Docket Number:	22-AAER-01
Project Title:	Commercial and Industrial Fans and Blowers
TN #:	242904
Document Title:	California Investor Owned Utilities Joint Comments on C&I Fans and Blowers NOPA
Description:	N/A
Filer:	System
Organization:	California Investor Owned Utilities
Submitter Role:	Public
Submission Date:	4/29/2022 5:17:23 PM
Docketed Date:	5/2/2022

Joint Comments on C&I Fans and Blowers NOPA

This letter comprises the comments of the Pacific Gas and Electric Company (PG&E), San Diego Gas and Electric (SDG&E), and Southern California Edison (SCE) in response to the California Energy Commission (Energy Commission) notice of proposed action (NOPA) regarding Commercial and Industrial Fans and Blowers.

Figure 1: Example of fan curve where FEI = 1.0, but FEP_{ref} is changing. FEP_{ref} at duty point A is higher than FEP_{ref} at duty point B. At all points along the curve representing FEI = 1.0, FEP_{ref} is equal to FEP_{act}.

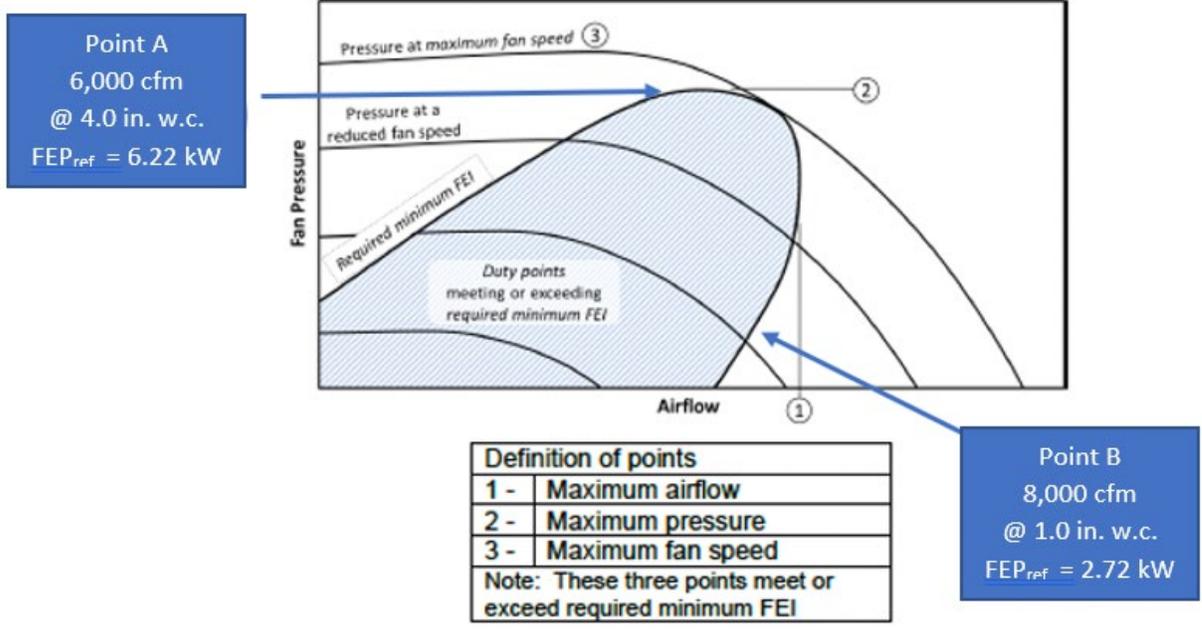
- 1. The CA IOUs recommend that the CEC remove the labeling requirement to report FEP_{ref} at $FEI = 1.0$, and we propose that the label not include the phrase "at $FEI = 1.0$."**

Fans do not have single values for FEP_{ref} and FEP_{act} at $FEI = 1.0$. Figure 1 shows an example fan curve with many duty points where $FEI = 1.0$. Each duty point has a different FEP_{ref} and FEP_{act} . For example, using Figure 1, we will assume that point A represents an airflow of 6,000 cubic feet per minute (cfm) and a pressure rise of 4.0 in. w.c., and Point B represents an airflow of 8,000 cfm at a pressure rise of 1.0 in. w.c. This fan would have an FEI of 1.0 at both points, but the FEP_{ref} of Point A is 6.22 kW, while the FEP_{ref} of Point B is 2.72 kW.

FEP_{ref} is a higher value at point A than point B, even though both have an $FEI = 1.0$. Therefore, we suggest CEC not include " FEP_{ref} at $FEI=1.0$ " as a required value for the label.

The CA IOUs also suggest that the phrase “at FEI = 1.0” not be used for any of the labeling requirements. The reported value on the label may be at a pressure, airflow, or fan speed where FEI is greater than 1.0. For example, the maximum fan speed may not be limited by FEI but by a motor power or structural limitation. Instead, we propose using “compliant,” as shown in the strikeout/underline text below.
